E4436B-10

S E R V I C E N O T E

ESG “B” Signal Generator E4436B

Defective Waveform Sequence SRAM on the Dual Arbitrary, UND board (A5) and iDEN Dual Arbitrary, Special Option H60 board causes waveform become distorted when playback.

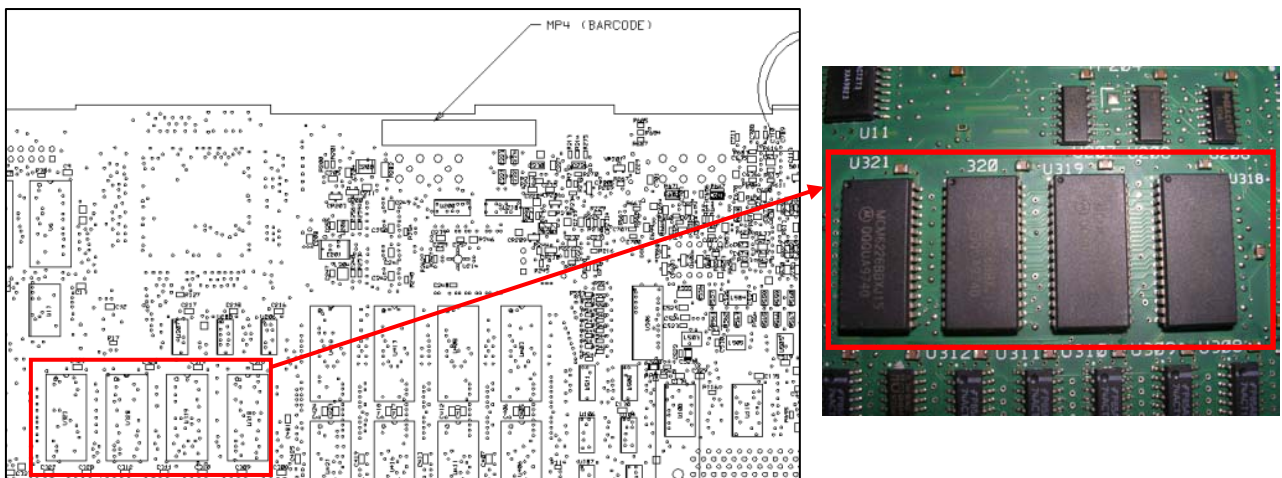
The ESG-B D/DP Family of Signal Generators has been experiencing failures in the UND (E4400-60187) and Option H60 (E4400-60186) board assemblies. This is due to a failure of the waveform sequence SRAM ICs. There are total 4 affected waveform sequence SRAM ICs on the UND and Option H60 assembly, designator U318, U319, U320, U321. The failure will cause the waveform playback become distorted. This may happen immediately after Arbitrary Function is turned on, or after it has been play-backed for a short period of time. This potentially happened when large waveform files are being playback. All ESG-B D/DP units with the symptoms mentioned above required the waveform sequence memory chips to be replaced. The kit, E4400-60753 contains 4 pieces of the SRAM ICs.

1. Repair on failure.
2. Prevent future occurrences due to a defective waveform sequence memory chips (U318, U319, U320, U321) by replacing the 4 affected chips.
3. Locate the U318, U319, U320 and U321 which are located at the bottom side of the UND or H60 board.

4. Replaced the affected components. **Caution:** Please use the appropriate soldering tools and you must be certified to perform the soldering to prevent any quality or reliability issue due to soldering workmanship.
5. Once the affected components had been replaced, perform:-
 - i) Dual Arb Waveform Generator Check. This test can be performed by using the TME software or the ESG-B Classics Software, and
 - ii) If customer waveform is stored in the NVARB RAM, playback the waveform and observed on the oscilloscope for any waveform distortion.
